Overall view of KY-MK3500 induction heater cook top (internal).

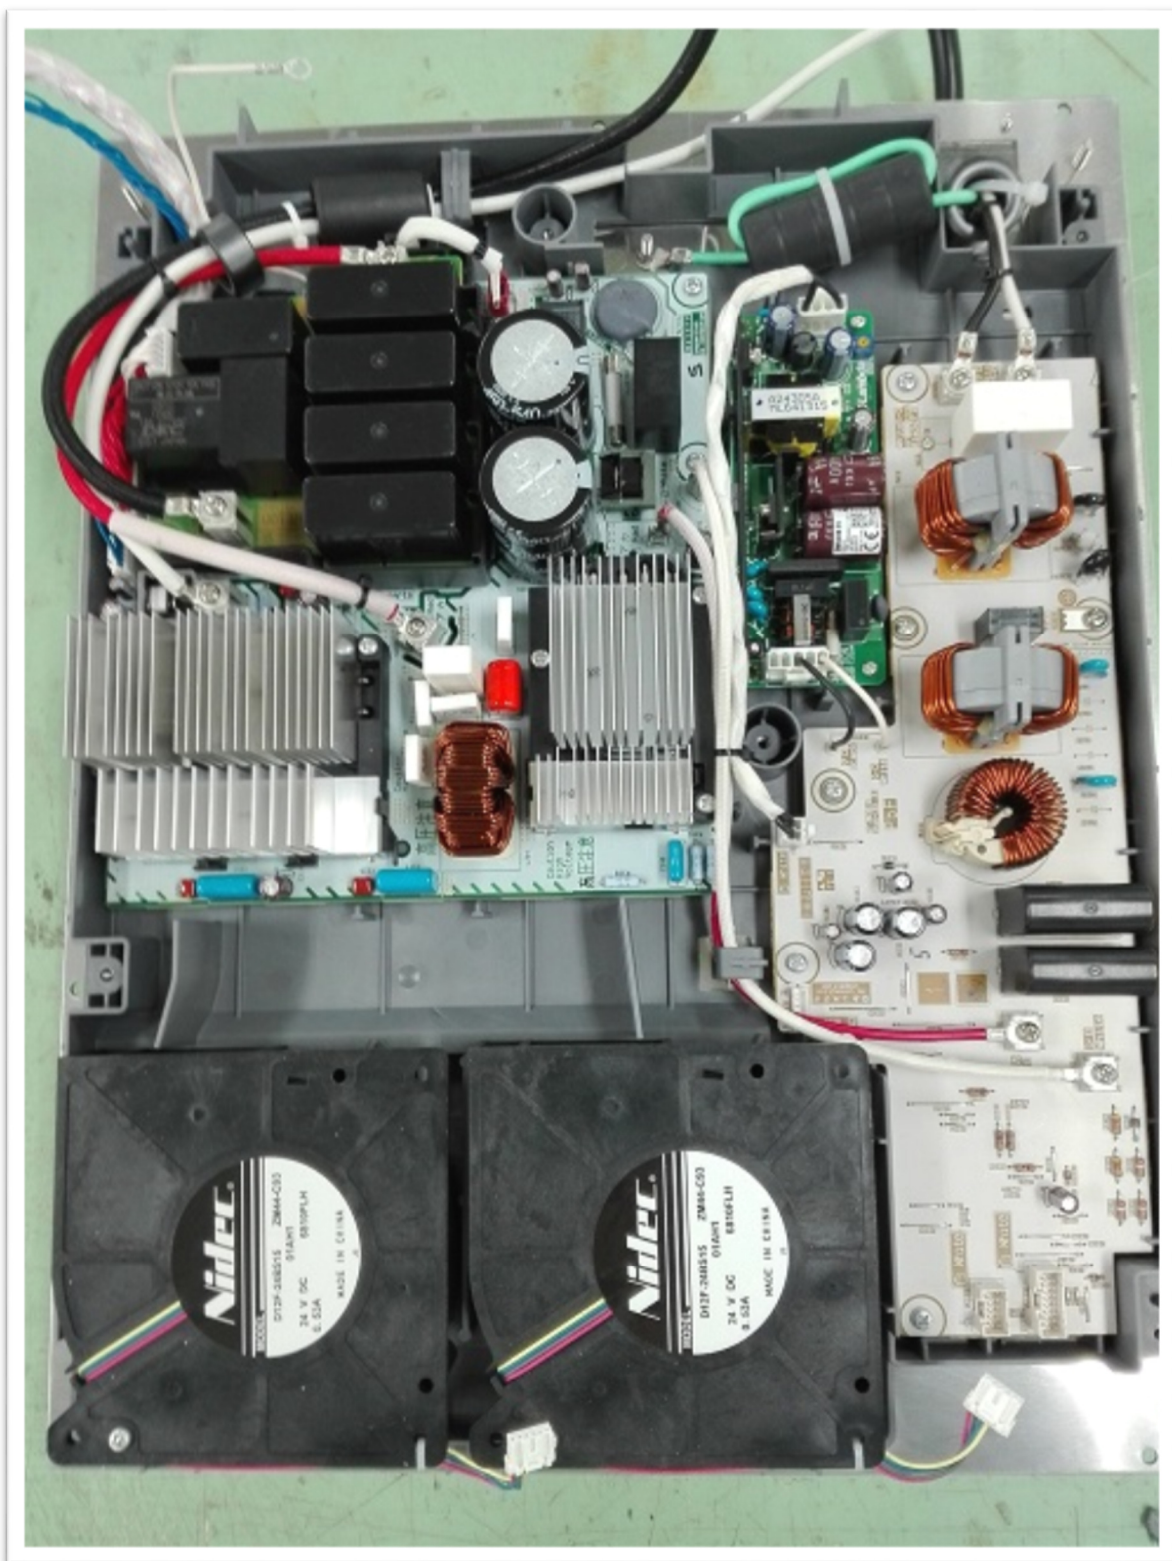
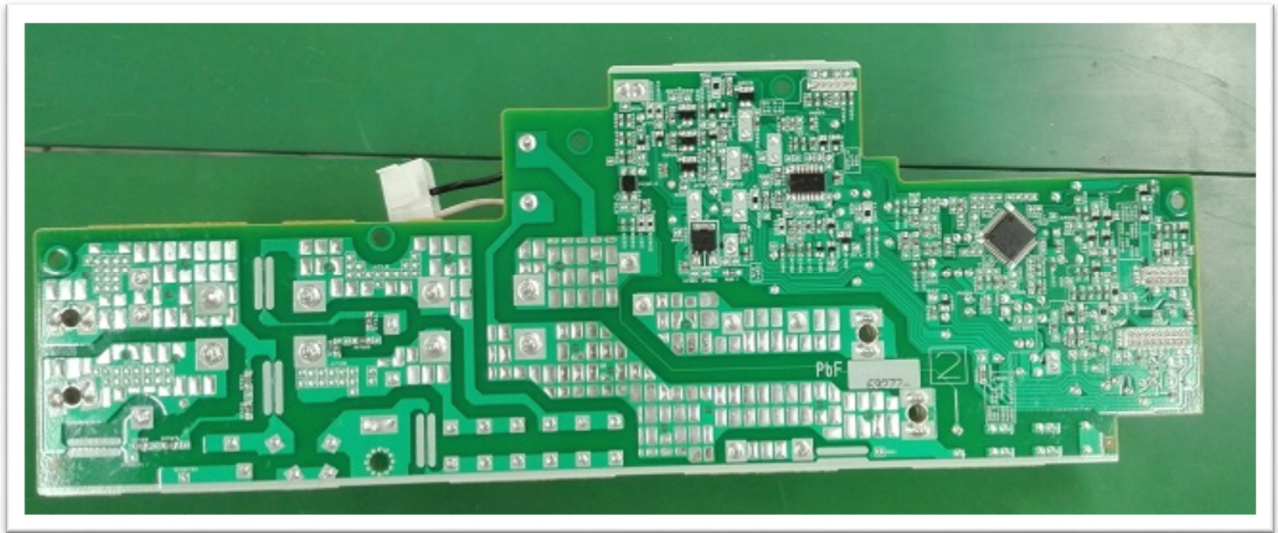
Trace layouts on the Noise Filter board were revised

Filter board (right) was revised to increase capacitance value of C701 from 4.7uF to 8.2uF and additional changes to ferrite core holder and PCB trace layouts.
